## ROOF REPLACEMENT

**DR. HELEN BALDWIN MIDDLE SCHOOL  
45 WESTMINSTER ROAD  
CANTERBURY, CT 06331  
STATE PROJECT #022-0016 RR**

**DATE: July 3, 2018**

The following changes to the Drawings and Project Specifications shall become a part of the Drawings and Project Specifications; superseding previously issued Drawings and Project Specifications to the extent modified by Addendum No. 1.

#### Series 3016 3" "T" Seam

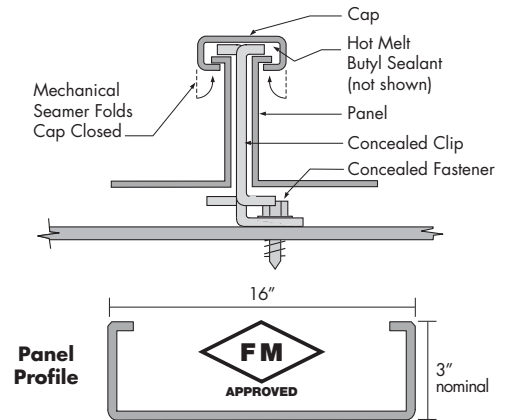
**There will be a slight difference in the seam height. Englert series 3000 has a 3" seam height and Imetco has a 2-3/8" seam height.**

**Specifications have been changed per Addendum #1 therefore this product does not meet the requirements.**

### Series 2500 2" Mechanically Seamed

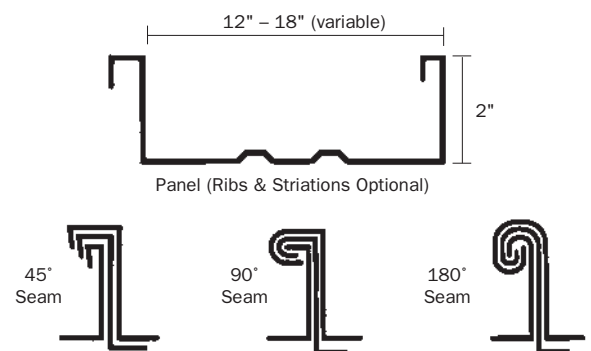
**Specifications have been edited per Addendum #1; therefore this product meets requirements.**
